UNITED STATES PATENT AND TRADEMARK OFFICE

Office Action Summary

10/673,398

- I. Claims 1-13, drawn to a cassette device, classified in class 206, subclass 711.
- II. Claim 26, drawn to a method of supporting mother substrates, classified in class 414, subclass 801.

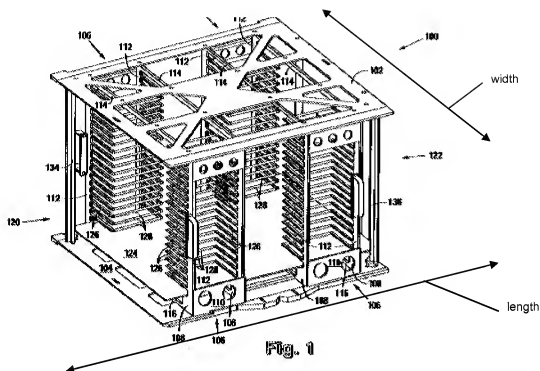
With respect to claims 1, 3 & 7-13, Babbs discloses a cassette device comprising-

- a frame 108 having a length greater than a width as well as a height, wherein a length and width of a frame correspond to a length of width of inserted mother substrates, respectively (see FIG. 1 reproduced below);

- a first support members 126 protruding from a first side of a frame and second support members 126 protruding from a second opposing side of a frame;

- first supporting bars 128 connected to first support members and second supporting bars 128 connected to second support members, wherein supporting bars are disposed a distance from a frame,

- wherein first and second supporting bars 128 contact and support a lower surface of an inserted mother substrates along first and second parallel sides of an inserted mother substrates at opposing parallel regions of a first lower surface, wherein first supporting bars are configured slightly spaced from each other and second supporting bars are slightly spaced (e.g. in a vertical sense) from each other, so that first and second supporting bars are in contact with substantially a whole width of the of first and second parallel sides of inserted mother substrates to uniformly distribute a load to the patterned spacers in substantially the whole width of the first and second parallel sides of the inserted mother substrates across the substrate.

Babbs does not disclose rectangular supporting bars connecting two support members. Babbs recognizes that mother glass boards (e.g. substrates) are "generally flat, rectangular plates made of amorphous glass with various sizes, including relatively large FPDs measuring 550 millimeters (mm) by 650 mm by 1.1 mm thick. The FPD industry trend, however, is towards larger substrates measuring 700 mm by 1000 mm, 850 mm by 1050 mm, and larger. Further, the trend is towards thinner substrates having thicknesses of 0.7 mm." C1/L12. Betsuyaku discloses a liquid crystal display panel cassette including rectangular supporting bars (FIG. 4: 3) that per international agreement improves "durability, sealing performance, good anti-staining performance, unmanned use, automation, ease of cleaning, etc." C1/L28. Therefore, it would have been obvious to one having ordinary skill in the art at the time the invention was made

Babbs does not disclose supporting bars disposed at a distance of about 170mm from a frame. However, Babbs discloses supporting bars of some distance from a frame, recognizes that sagging substrates require longitudinal support, and that the industry trend is coordinate cassette size to substrates having dimensions such as 650mm, 550mm, 700mm, 1000mm, 850mm, 1050mm, and thicknesses of 1.1mm & .7mm. C4/L26-40. A skilled artisan knowing Babbs' apparatus solves sag which is affected by width of supports would know to size Babb's apparatus at any size that prevents sag, including 170mm, a dimension well within the range of sizes Babb's support members are designed to support. Therefore, it would have been obvious to one having ordinary skill in the art at the time the invention was made to modify the apparatus of Babbs to include supporting bars disposed at a distance of about 170mm from a frame as is well known when supporting large substrates and preventing sag.
